ONS-2015-055

Subject: Second Response to Request for Additional Information dated October 23, 2014,
Related to Southeastern Catalog Changes and Seismic Re-Evaluations

Oconee Nuclear Station Units 1, 2, and 3, Duke Energy Response to RAI:
Senior Seismic Hazard Analysis Committee (SSHAC) Level 2 Study

Figure 16: Seismicity with $E[M] \geq 2.9$ occurred within 100 km of the Oconee NPP from 1968 through December 2007: a) from Rev 7 of the CEUS-SSC earthquake catalog; b) from Rev 8.

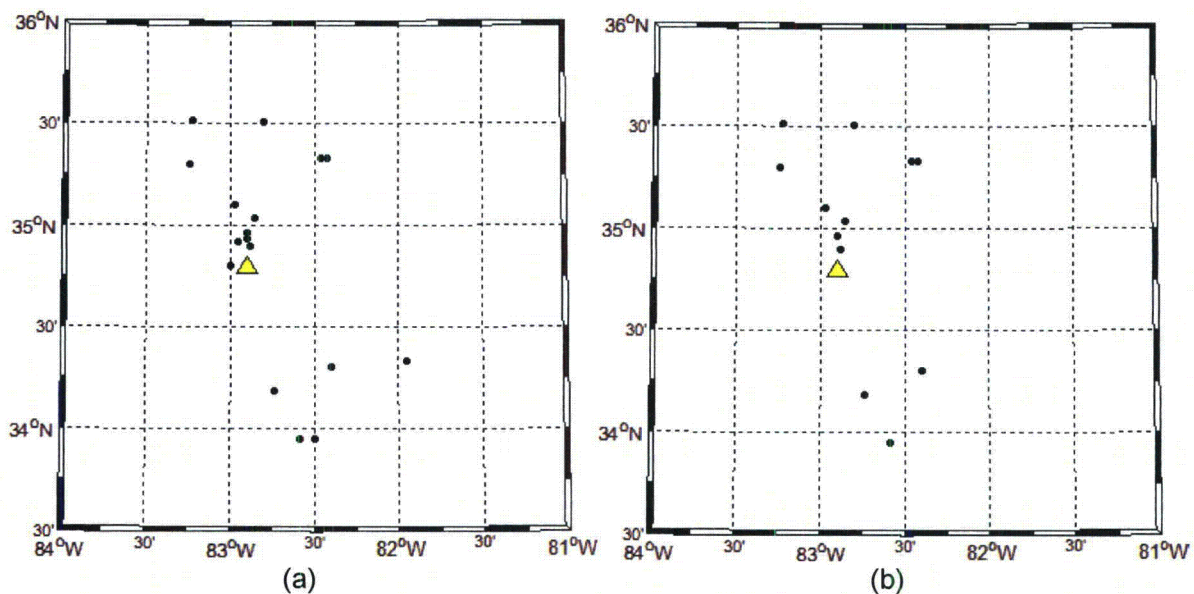
Figure 1 shows that the events in Table 4 are located in proximity of two NPPs: Oconee and VC Summer. The earthquakes located within 100 km of each NPP were plotted and analyzed to identify any other cluster of seismicity of non-tectonic origin. Figure 16 compares the earthquakes with $E[M] \geq 2.9$ that occurred from 1968 to December 2007, located within 100 km of the Oconee NPP, from Rev 7 of the CEUS SSC Catalog (Figure 16a) and from Rev 8 (Figure

16b). The comparison indicates that the analysis presented in this report has removed several earthquakes that had previously been used to calculate recurrence rates for PSHA.

Figure 17: Seismicity with $E[M] \geq 2.9$ occurred within 100 km of the VC Summer NPP from 1968 through December 2007: a) from Rev 7 of the CEUS-SSC earthquake catalog; b) from Rev 8.

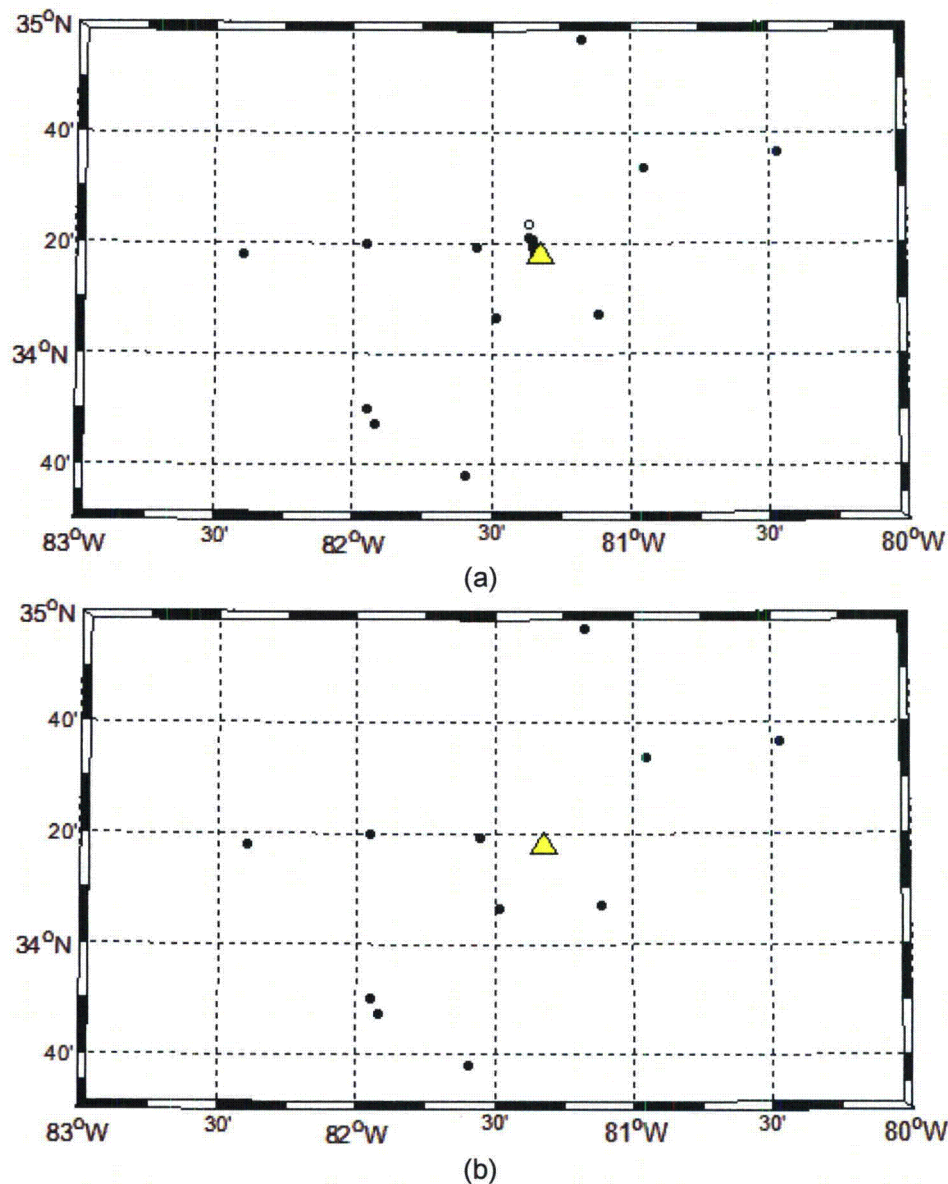
Figure 17 shows a similar comparison for the seismicity within 100 km of the VC Summer NPP: Figure 17a shows the earthquakes in Rev 7 of the catalog with $E[M] \geq 2.9$ occurred from 1968 to December 2007; Figure 17b shows the earthquakes from Rev 8 of the catalog. The cluster of earthquakes associated with the Monticello Reservoir has been effectively removed from the earthquake catalog in Rev 8.

Figure 18: Isoseismal map for January 19, 1860 earthquake provided by Donald Stevenson and Dr. Predeep Talwani (written communication, February 19, 2014).

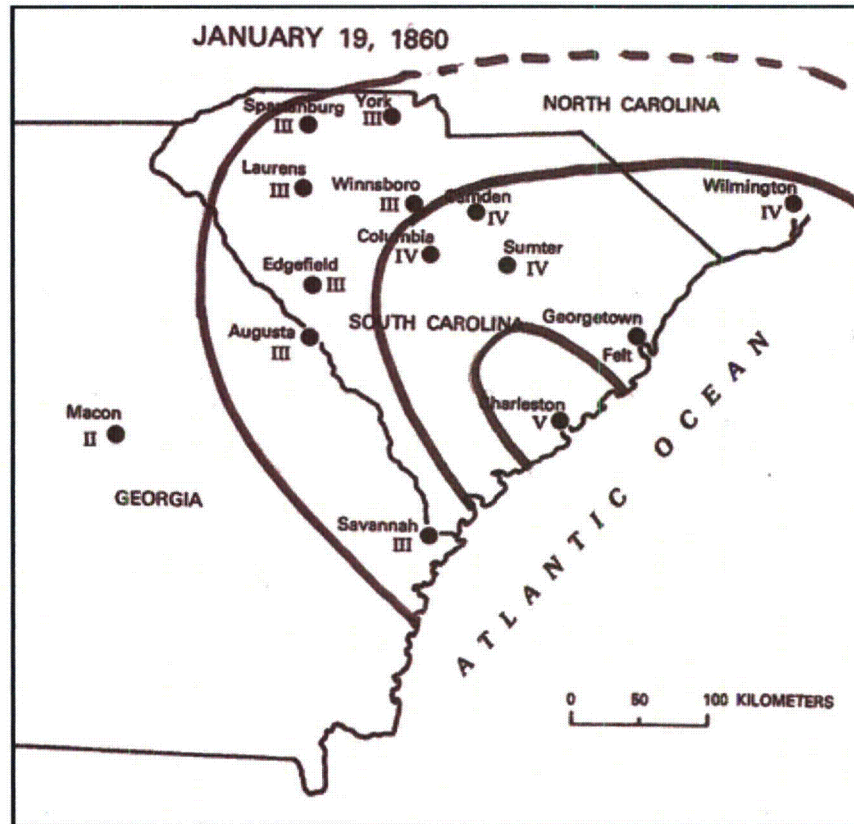
The location in the Rev 7 catalog is based on NCEER-91. Donald Stevenson and Dr. Predeep Talwani provided the isoseismal map shown below based on their interpretation of the available intensity data. This interpretation suggests a location near Charleston. The recommendation is to utilize the Charleston location given in the SUSN catalog.

Figure 20: Comparison of In(FA)-I0 data for Category 4 Earthquakes from Seeber and Ambruster (1987) with data from other earthquakes from the CEUS SSC Rev 7 catalog.

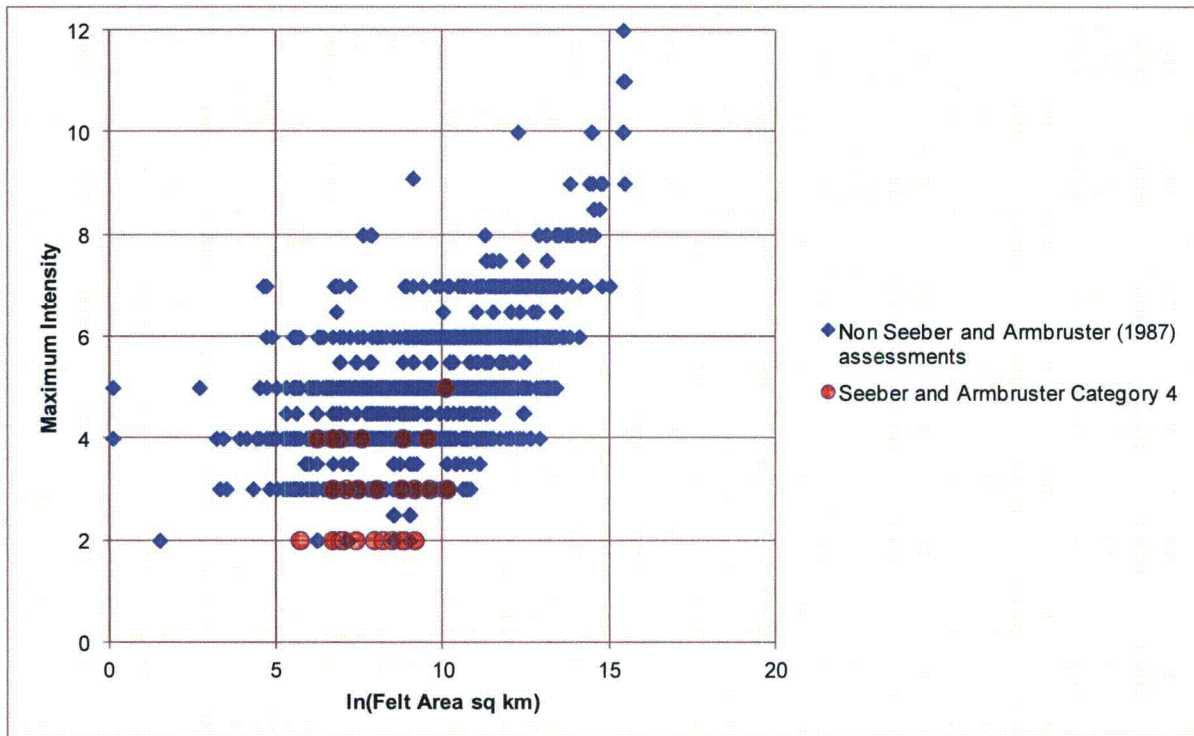
The comparisons for the Category 4 earthquakes on Figure 20 show general consistency in the I_0 - $\ln(\text{FA})$ data with the rest of the catalog. Many of the Category 4 earthquakes have locations near Charleston. These events are left in the catalog.

Although this event was listed as a category 4 earthquake in Seeber and Armbruster (1987), it was not carried forward into NCEER-91. Also the $\ln(FA)$ of 8.46 is anomalous compared to the I_0 of II (Figure 20). The recommendation is to not use the felt area reported by Seeber and Armbruster (1987), which will result in the event not being considered in estimation of earthquake recurrence.

Although this event was listed as a category 4 earthquake in Seeber and Armbruster (1987), it was not carried forward into NCEER-91. Also the $\ln(FA)$ of 8.92 is anomalous compared to the I_0 of II (Figure 20). The recommendation is to not use the felt area reported by Seeber and Armbruster (1987), which will result in the event not being considered in estimation of earthquake recurrence.

Figure 21: Comparison of $\ln(\text{FA})-I_0$ data for Category 5 Earthquakes from Seeber and Armbruster (1987) with data from other earthquakes from the CEUS SSC Rev 7 catalog.

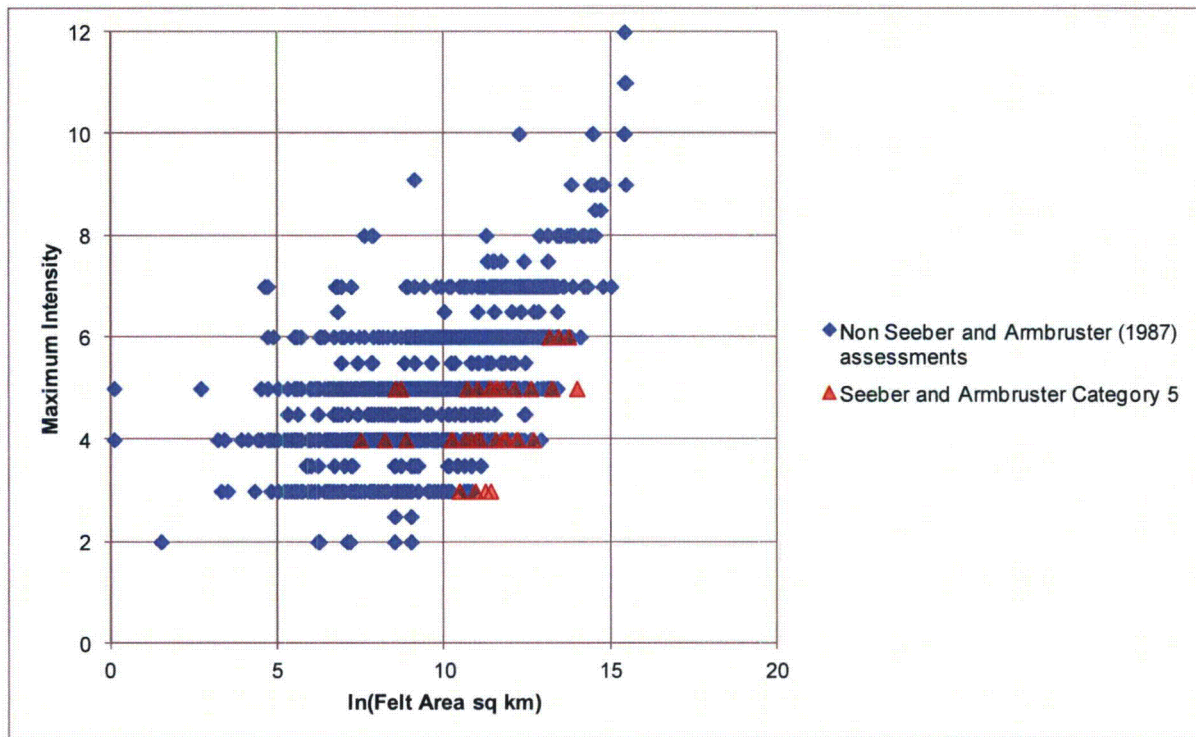
The remaining question is the large number (about 25) of the Category 5 earthquakes. A number of these have SUSN entries with the same time, but often significantly different locations. Category 5 is considered by Seeber and Armbruster (1987) as the best located. Five of the interpreted mislocated earthquakes discussed in Part 2 are Category 5 earthquakes, indicating that there are issues with some of these locations. In addition, the data shown on Figure 21 indicate that the assigned $\ln(\text{FA})$ may be biased high for this category. These events were examined again in comparison to other events in the catalog from SUSN.

This is a Category 5 earthquake in Seeber and Armbruster (1987) and is listed in NCEER-91. Its I_0 (IV) and $\ln(FA)$ (8.22) are consistent with the general population of CEUS SSC earthquakes (see Figure 21). Stevenson and Talwani (written communication, Feb 26, 2014) indicate:

▲ Figure 1. Intensity data for the earthquake on October 22, 1886 at 10:20 UTC. The assigned radii for intensities IV and V are shown by dashed arcs.

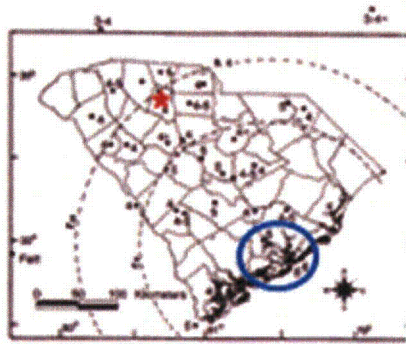
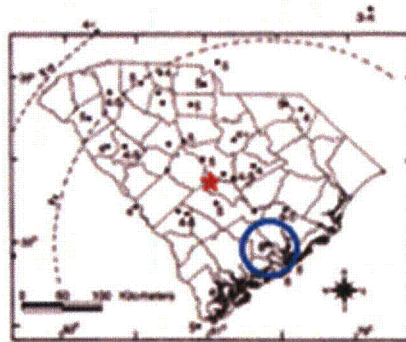
4. **TMP02019 and 02025:** These are two aftershocks of the Charleston earthquake. They were felt over a wide area. The macroseismal data were evaluated by Talwani and Sharma (1999), who located it in the Summerville area and revised the magnitude estimates.. Isoseimal data for these earthquakes and the revised locations by Talwani and Sharma are shown on the maps below taken from that paper, and compared with the WRONG locations (red stars) listed in the existing catalog.
